Design Review Board Agenda

**CITY OF MILL CREEK
DESIGN REVIEW BOARD
APPLICATION PL2018-0001**

NAME OF PROJECT: Murphy's Corner Starbucks

**CITY OF MILL CREEK
DESIGN REVIEW BOARD
APPLICATION PL2017-0033**

Attachment 5 – Landscape Plan (Sheet L-1001)

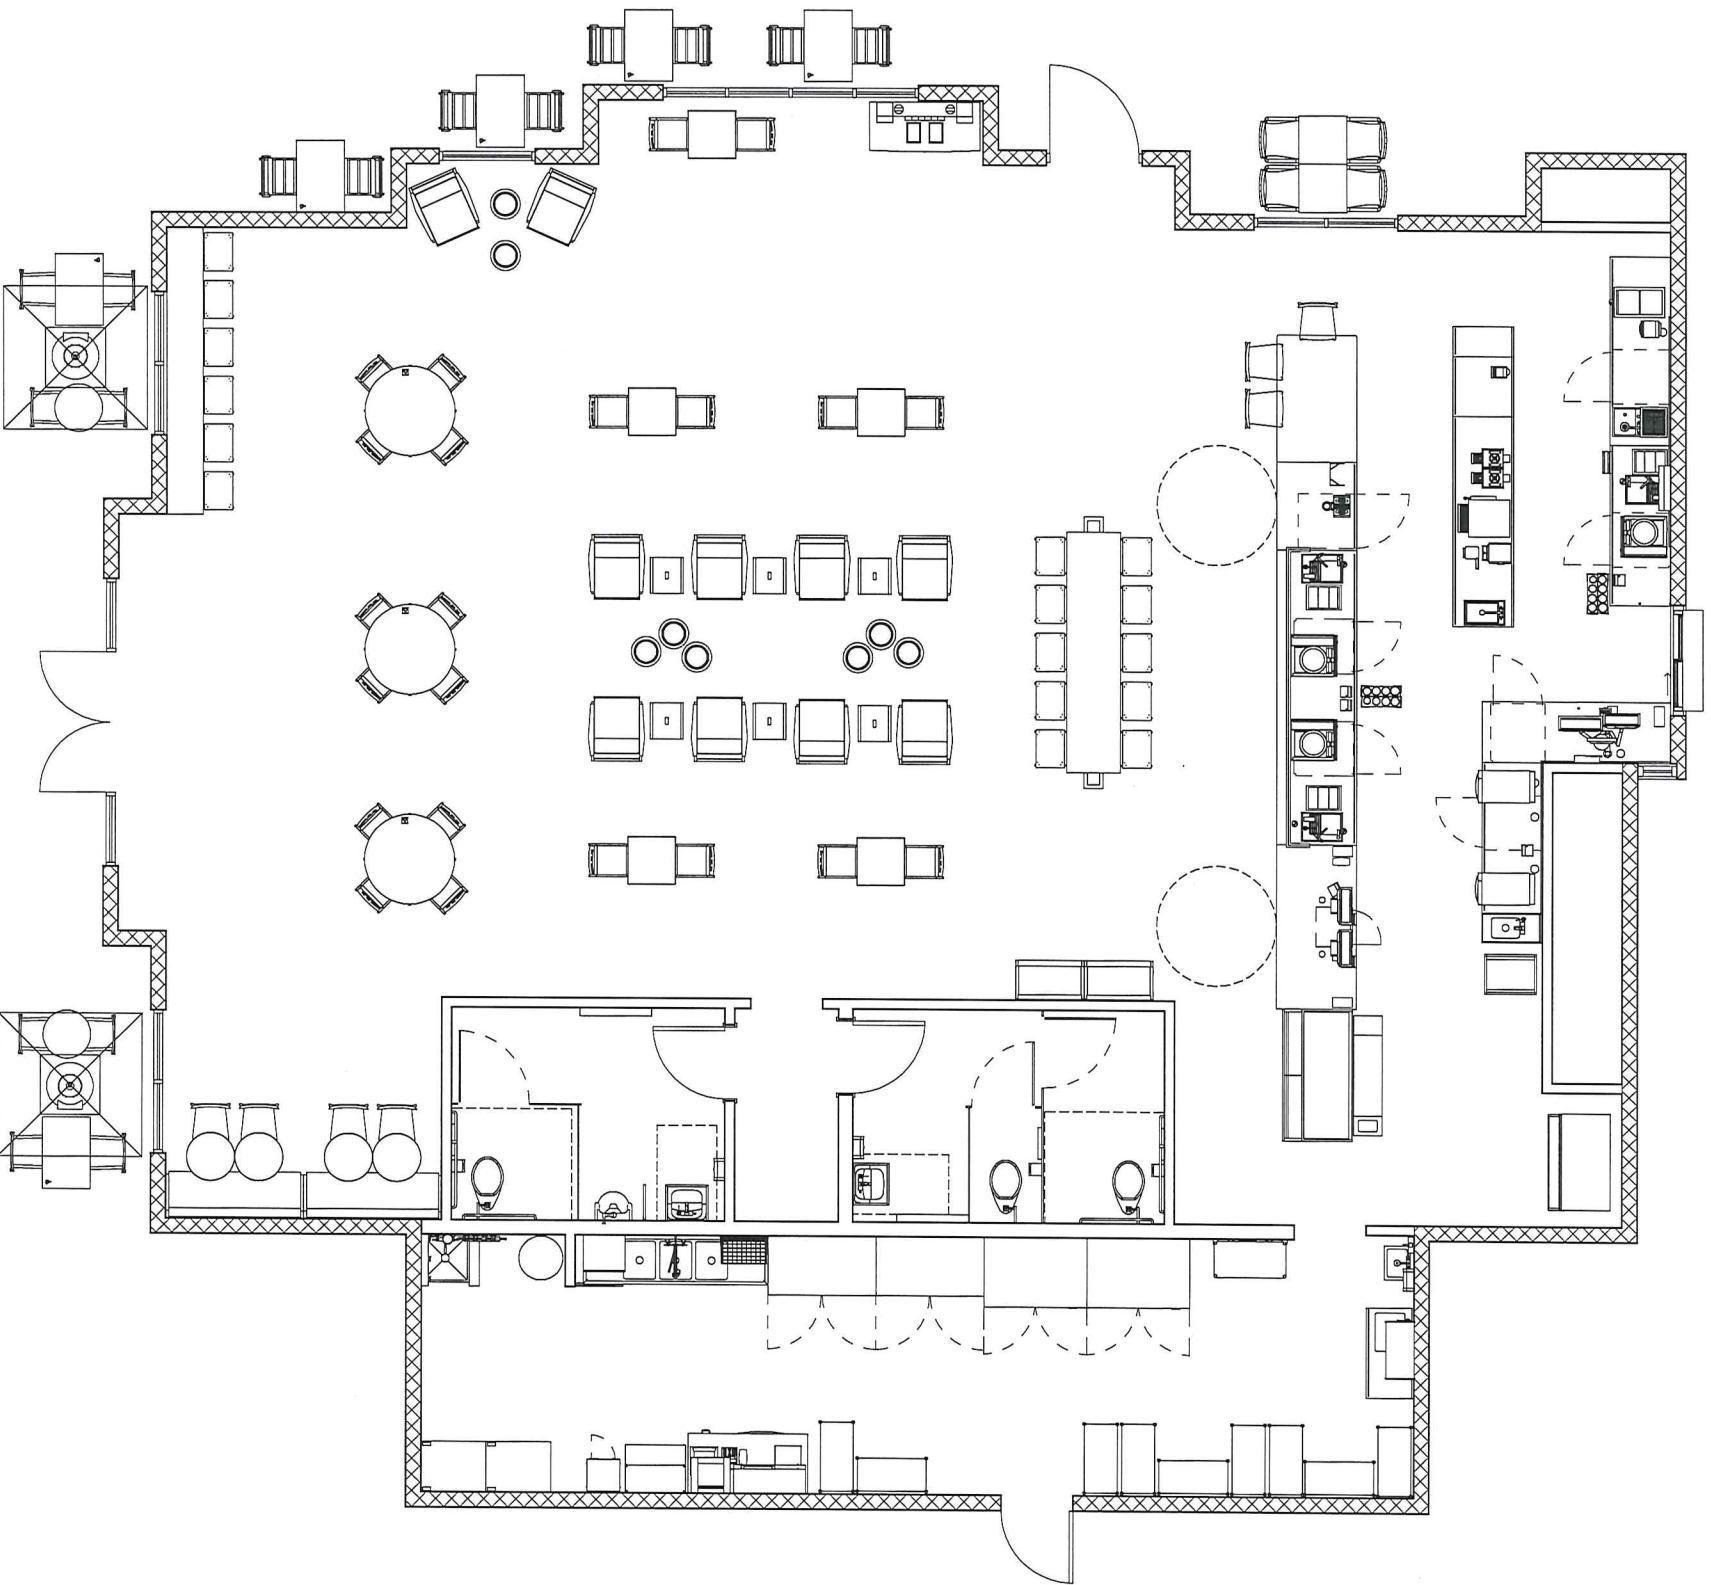
The existing landscaping is in relatively good shape and will be retained. Staff is recommending a Condition of Approval requiring that the existing landscaping be refreshed by weeding and replacing any shrubs that have failed. In addition, a portion of the asphalt adjacent to the drive-thru area is proposed to be removed and the area planted with shrubs. Please refer to **Attachment 5 – Landscape Plan** for additional details.

Design guidelines require that project landscaping be hardy, adaptable to local conditions, easily maintained, and drought tolerant. Use of native plants and the retention of existing vegetation are strongly encouraged. The only area where new landscaping is proposed is the area to the north of the drive-thru window where the asphalt will be removed. The applicant is proposing a mix of shrubs, including: Otto Luyken, David's Viburnum, and assorted dwarf rhododendron and a Vancouver Jade

Kinnikinnick groundcover. The proposed shrubs are consistent with a majority of the design guidelines.

The design guidelines also require that landscaped areas be irrigated by mechanical sprinkler systems; thus, staff is proposing a Condition of Approval requiring irrigation for the new landscape area.

1. The building elevations, materials, colors, and design shall be as portrayed in the application.
2. Refresh the existing landscaping by weeding and replacing any shrubs that have failed. If any shrubs need to be removed to replace the air conditioning units, replant shrubs that will adequately screen the new utilities.
3. Provide irrigation for the new landscape area in accordance with MCMC 17.34.040.H.1.d

Attachment 1 – Sign Plan

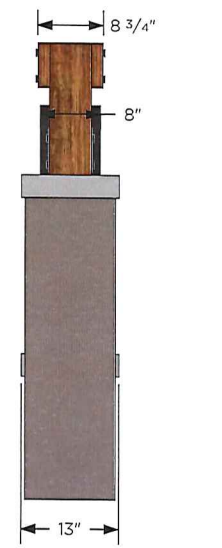
The applicant is proposing to retain the existing stone supporting structure and is proposing to exchange the existing florescent tube cabinet with a new LED cabinet. The new sign cabinet is 22 square feet for each sign for a total of 44 square feet, well below the 64 square feet allowed in the Code. The applicant is also proposing to add a wood trellis to the top of the existing supporting structure to enhance the modern lodge look. The supporting structure is 64 square feet for each sign for a total of 128 square feet, which is the maximum allowed by the Code. The proposed sign height is approximately five feet, which is below the seven feet allowed by the Code.

The proposed sign is to be internally illuminated with LED lighting. The MCMC requires that freestanding signs that are internally illuminated emphasize the lighting of the sign text, message and/or symbols, while minimizing the lighting of the background of the sign face. The proposed sign is consistent with this requirement as only the lettering is proposed to be a translucent white vinyl and the background will be painted black.

The stone and wood of the sign supporting structure are complementary to and coordinate with the adjacent apartments, in accordance with MCMC Section 17.34.040.G.3.

The sign will have only the name of the apartments - Hawthorne Apartments, which is consistent with the Code.

As proposed staff believes the new monument signs are consistent with the dimensional requirements contained in MCMC Chapter 17.26 and the design guidelines contained in MCMC Chapter 17.34.

1. The sign design, materials, and colors shall be as portrayed on the materials submitted with the application, except as may be modified by the conditions imposed by the Design Review Board.
2. The sign shall not be installed until a sign permit is issued by the Building Official.
